## SERVICE BULLETIN

NUMBER 012

MODEL AL, AE, EL

### A SERIES & E SERIES ENGINE OIL FILTER DESIGN CHANGE

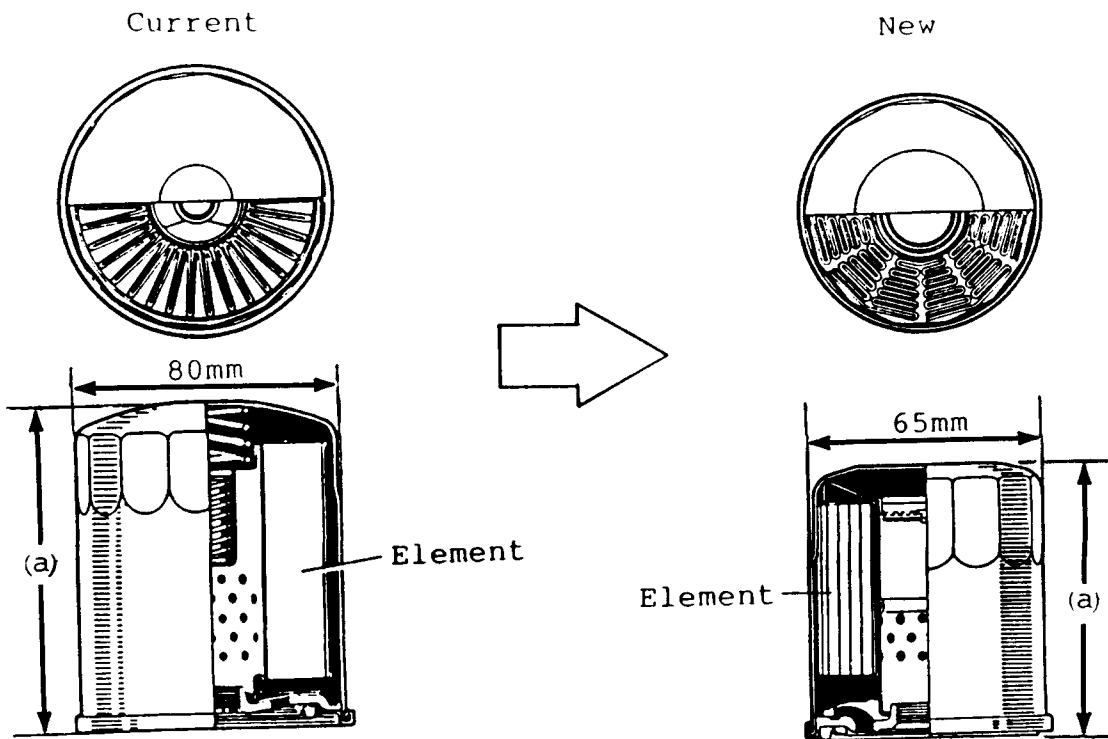
For part standardization, the oil filter on A series and E series engines has been changed to a newer full flow type shown below:

Dimension A

Engine Series		Current	New
E	➔	80 mm	75 mm
A	3A-C, 4A-LC, 4A-F	100 mm	75 mm
	4A-GE, 4A-GZE	100 mm	90 mm
